Doc. No. : PCN 130801 **Date :** 2013/08/05

Product Change Notice

SOD-123H Devices Change for Overall Appearance

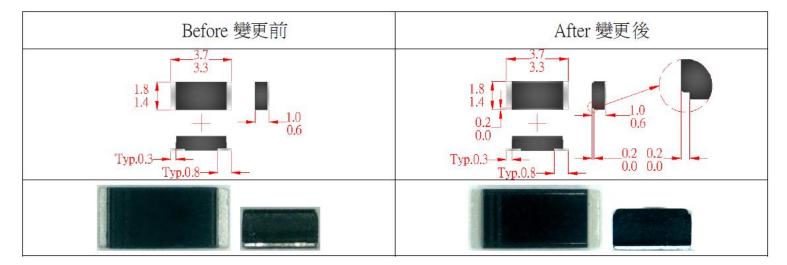
CGRMT4004-HF / CGRMT4007 series will be changed and produced by new mold. Changes of size are shown as below pictures:

- 1. Current molding design is strip-type mold. It tends to cause chipping on the edge of devices after singulation by multi-cutter technic.
- 2. Productivity and inspection becomes low and difficult according to our standard of chipping(<0.2mm).
- 3. Therefore, our supply cannot meet demand from customers.
- 4. Strip-type mold is replaced withmulti-cavity of strip type mold. To limit the range of chipping bythe

trenches which facilitates devices to conform with standard of chipping after cutting technic.

- 1. Change of overall molding will not affect the readability of marking.
- 2. Change of overall molding will not affect electricity characteristics and hermetic seal.
